Technical Bulletin No. 61

Topic: KWIK/Dorsey Rear Bolster Corrective Action

Examples of Extended Stress Fractures

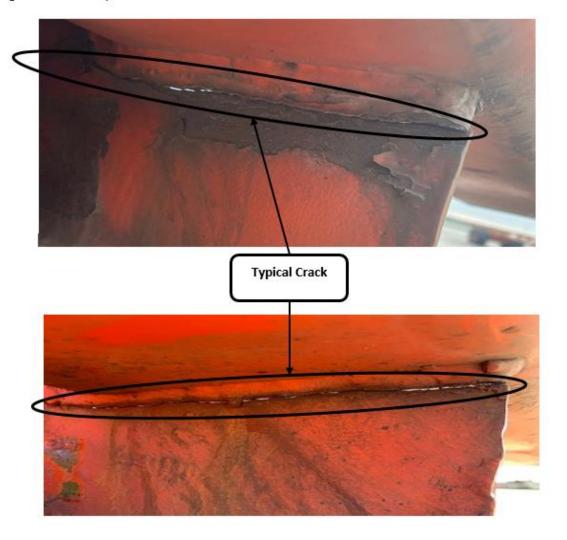
Several of the Kwik/ Dorsey 20SL chassis manufactured between 2017 and 2019 have been identified with cracks in the main rails and between the main rails and the rear bolster.

The defect observed is identified as a crack running across the bottom width of the rear bolster on both sides. In the more severe cases the crack either extends up the rear vertical weld on the rear bolster and/or fractures the main rail web at rear of the bolster.

Repair description Disconnect ABS. Remove paint from affected areas, stop drill and "V" all cracks. Weld all

cracks and Stop drill holes, and install gussets per specification. Repaint all welding in matching color. All gussets are to be painted YELLOW only. Reconnect ABS. All painting is to be taped and blocked to ensure a professional appearance upon completion. Time
